## ORGANIZACION HIDROGRAFICA INTERNACIONAL

Dossier del BHI N° S3/4405

CIRCULAR No. 07/2012  
26 de Enero del 2012

### ESPECIFICACIONES CARTOGRAFICAS DE LA OHI (S-4)

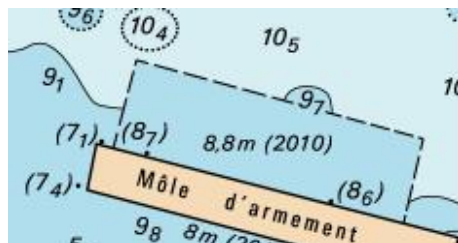
- If the scale is too small to show the dredged limit parallel with the berth, it is still possible to show some 'out of position' soundings alongside, in parentheses either within the dredged area or on the adjacent land, as explained in B-412.2; see also B-414.5, eg:
